SR-2 – ADVISORY STAFF REPORT (08-12-2026)

ADDRESS: 1531 PARKER

APPLICATION NUMBER: HDC2026-00414

SCOPE PHRASE: CONSTRUCT NEW DORMERS AT ROOF

Photo of existing roof. Note hipped roof dormer at the front façade (yellow arrow) roof surface and chimney at rear which is proposed for removal (red arrow). Photo by applicant

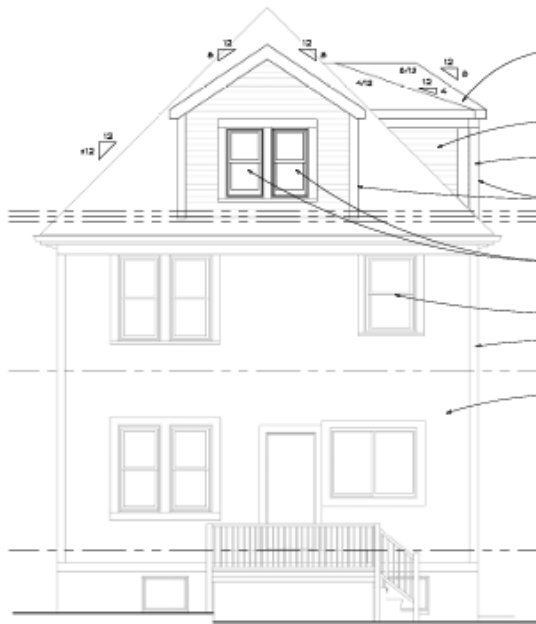
- The new dormer proposed for the rear roof is compatible in design with the building historic appearance as it will display wood siding and trim, double-hung wood windows, and a simple gabled roof which will sit well below the ridge of the main roof. As noted above, the existing chimney will be removed to accommodate this dormer. Though chimneys should typically remain on houses as an important roofline element enhancing complexity and texture, in this case staff does not assess that its removal for the dormer as demonstrably inappropriate as the chimney is not a distinctive, character-defining feature of this Colonial Revival, Foursquare plan dwelling due to its starkly utilitarian character. Staff therefore recommends approval of this dormer because it is a compatible addition to the property which will not destroy important historic character or sight lines and is additionally compatible with the district's Elements of Design and the character of surrounding houses.

Proposed roof plan, by applicant. Yellow arrow indicates the roof of the new south side dormer

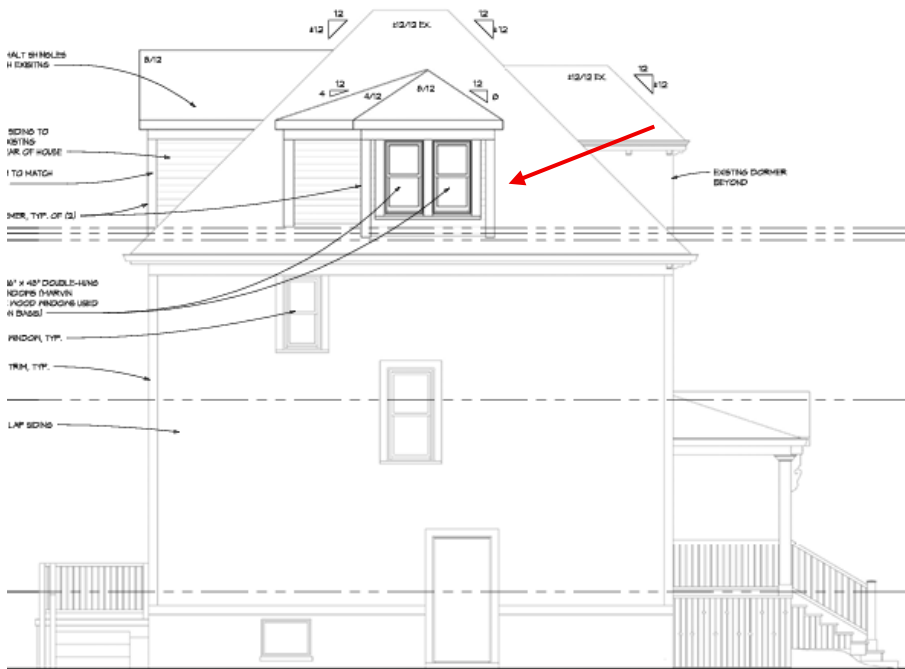
1. The roof shape of the new dormer proposed for addition to the south/side is incompatible with the house's historic character
2. The application does not provide documentation that the two historic, character-defining wood windows at the front dormer are deteriorated beyond repair

1. The new south side dormer design shall be revised to include a simple hipped or gabled roof which is located well below the ridge of the house's main roofline. The new dormer shall also be of a scale which is compatible with the house's historic character. HDC staff shall be afforded the opportunity to review and approve the dormer's final design prior to the issuance of the project's permit
